Dart Aerospace Ltd. Thursday, 3/23/2006 3:52:09 PM 1,47 Kim Johnston ₩Jser: **Process Sheet** : CU-DAR001 Dart Helicopters Services **Drawing Name** : 206 L WEB Customer Job Number : 26365 : 10722 **Estimate Number** : D26547 : NIA **Part Number** P.O. Number : D2654 REV E1 S.O. No. : N/A **Drawing Number** : 3/23/2006 This Issue : N/A : NC Project Number Prsht Rev. : LANDING GEAR : E1 : 3/23/2006 Type **Drawing Revision** First Issue : N/A : 25107 Material **Previous Run** : 3/30/2006 Qty: 3 Um: **Due Date** Written By Checked & Approved By Fixed typo, Changed procedure DM Comment : Est Rev:D 99.02.04 **Additional Product** Job Number: Description: **Machine Or Operation:** Seq. #: D26007125 Extrusion 'I Beam' thick 1.0 3.0000 Each(s) Comment: Qty.: 1.0000 Each(s)/Unit Total: Pick: Description Qty Part Number B 21130 3 IT 06-07-30 Web D2600-7- 125 2.0 LANDING GEAR Comment: LANDING GEAR RESOURCE 1 1-Cut D2600-7 to length as per Dwg D2654 TT 06-03-30 (3) 2-Drill pilot holes in web using drill jig DT 8018-7 as perDwg D2654 06-03-70 3 3-Using the uni-bit, open holes to finish size as per Dwg D2654 4-Deburr holes and ends 3.0 QC5

David Shepherd [davids@dartaero.com] From: Monday, Apri

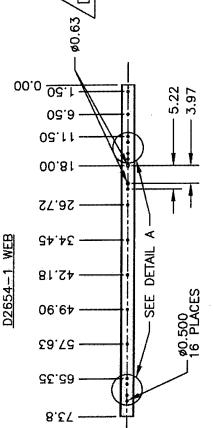
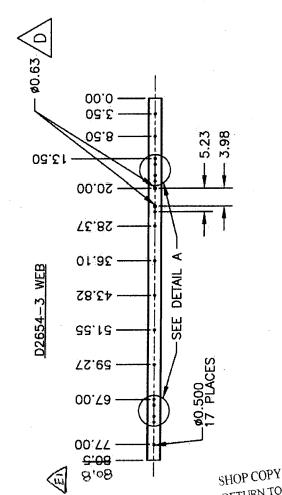
NCR:		W	ORMANCE (NCR)						
		Description of NC	Corrective Action		Section B		Verification	Approval Chief Eng	Approval QC Inspector
DATE	STEP	Section A	Initial Action Descript Chief Eng Chief Eng		otion Sign & Date		Section C		
06.04.03	2	.750 hole (105.00" location) was drilled that at the opposite and Alleman Error	ano	holes me acceptus	le. Drill	St of of	2	18 action	4.04.03
	2				:		6.04.03	A. Francisco	6.04.05
	-				,	E			•
	15,		,			E

> Dave, > D2654-7 Web for the 206L. They opened the hole for the towring on the > end by mistake, so both ends will have a 0.75" dia hole now. > affected by this. I see no problem with this myself. > Sincerely, > Chris Provencal > DART Aerospace Ltd. > Email..cprovencal@dartaero.com > Phone...613-632-3336 > Fax......613-632-4443

This is an acceptable deviation.
